TRUNK LATCH ACTUATOR RELAY LEVER UPGRADE KIT

OE: 1J5 827 567A

Triscan SELECT: 8900 29588

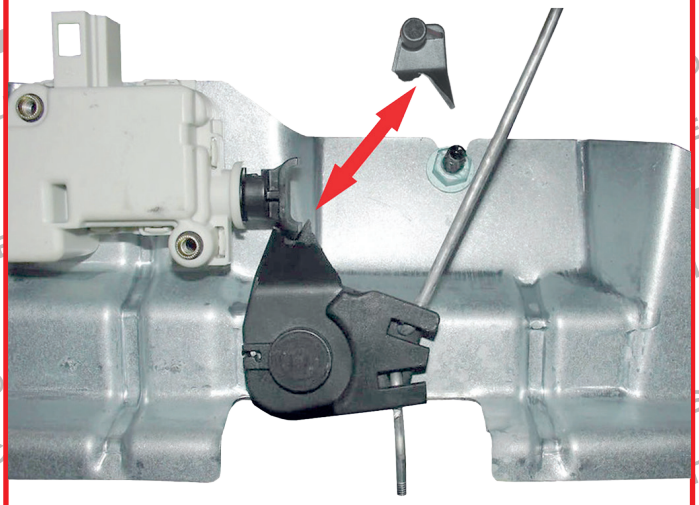
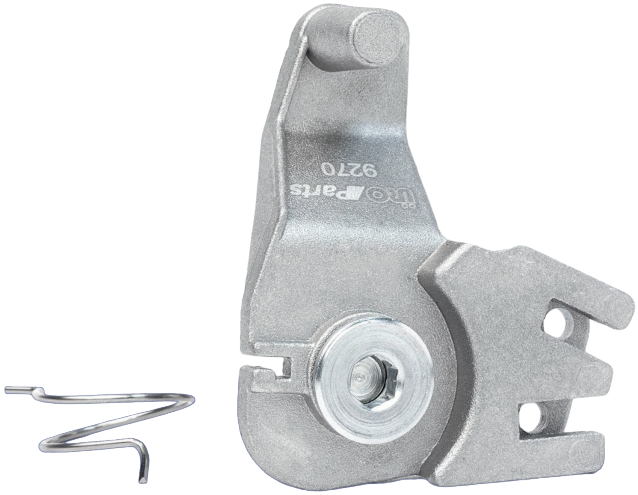
The trunk release actuator found in the VW Jetta MK4 is known for breaking the thin plastic relay lever, which disables the latch release mechanism. Repair typically requires replacement of the entire actuator bracket assembly, which is no more durable than the original failure-prone assembly.

- Actuator usage breaks the plastic relay lever, especially during cold weather.
- Replacement of OE bracket assembly is a costly yet temporary repair, and doesn't resolve the fragile relay lever issue.

Triscan SELECT redesigned the plastic actuator relay lever using metal for vastly improved reliability. The Triscan SELECT lever is made of sturdy aluminium and reinforced with structural ribs, making the lever exponentially stronger than OE. Now you can permanently repair the actuator bracket instead of replacing it!
